Docket No. 50-352

SUBJECT: Limerick Generating Station, Unit 1
Response to Request for Additional Information Regarding
Technical Specifications Change Request No. 95-03-1

**EXCERPT FROM NEDC-31300 "SINGLE -LOOP
OPERATION ANALYSIS FOR LIMERICK GENERATING
STATION UNIT 1", DATED AUGUST 1986
(5 PAGES)**

Figure 2-1. Illustration of Single Recirculation Loop Operation Flows

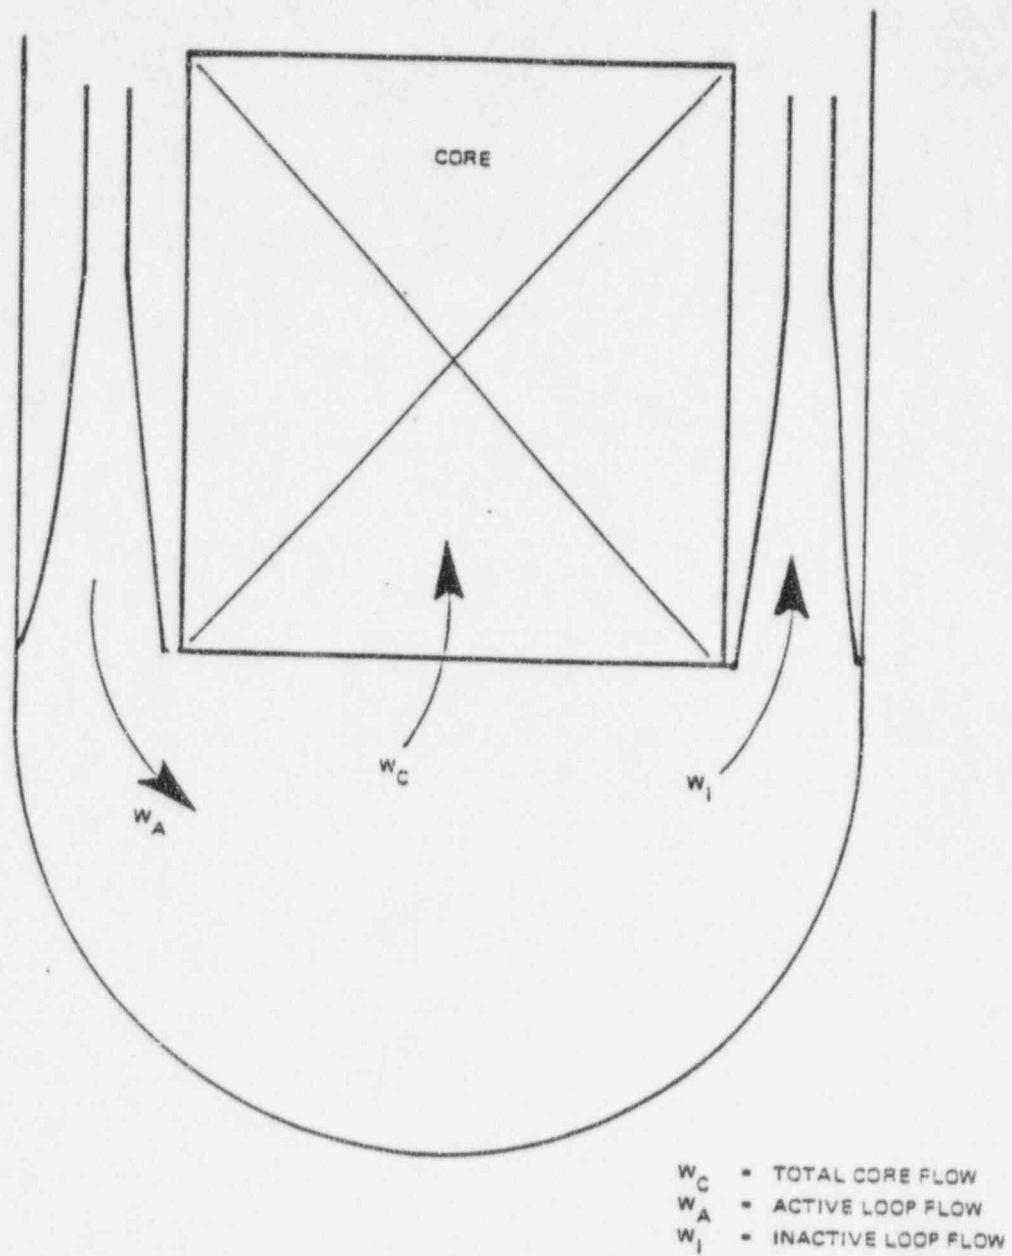
For SLO, the total core flow can be expressed as follows (refer to Figure 2-1):

$$W_C = W_A - W_I$$

$$\sigma_{W_C}^2 = \sigma_{W_{\text{sys}}}^2 + \left(\frac{1}{1-a}\right)^2 \cdot \sigma_{W_{A_{\text{rand}}}}^2 + \left(\frac{a}{1-a}\right)^2 \cdot \left(\sigma_{W_{I_{\text{rand}}}}^2 + \sigma_C^2\right)$$

$$\sigma_{W_C}^2 = (1.6)^2 + \left(\frac{1}{1-0.36}\right)^2 \cdot (2.6)^2 + \left(\frac{0.36}{1-0.36}\right)^2 \cdot \left[(3.5)^2 + (2.8)^2\right]$$
